## D/DRC Case

726-730 Woodrow Street

**DESIGN/DEVELOPMENT REVIEW COMMISSION**  
**DESIGN REVIEW DISTRICT**  
**HISTORIC AGENDA**  
**EVALUATION SHEET**  
Case # 1

**NATURE OF REQUEST:** Request Certificate of Design Approval for exterior changes

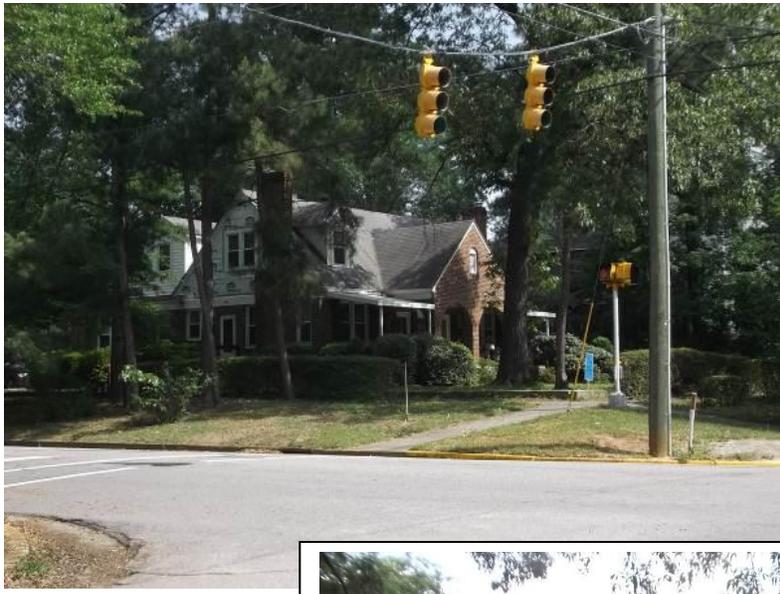
The removal of the original smooth, flat stucco and replacement with horizontally oriented vinyl siding is a dramatic change in appearance for the gables and dormers on this building; it does not preserve the form, size or details of the original siding. While replacement

materials are allowed in this district, they should meet this guideline for preserving the appearance of the original material. The stark contrast between the stucco and the vinyl does not retain the historic appearance of the building and does not meet this guideline. Staff can work with the applicant on the installation of a material that better mimics the original stucco, such as cement fiberboard sheets.

The permitted materials above include vinyl siding, but it would be appropriate for a request that also met the guideline above (4a), such as the application of vinyl siding over horizontally oriented wood siding.

Staff finds that the proposal does not meet Section C of the guidelines and recommends that the request for Certificate of Design Approval be denied.
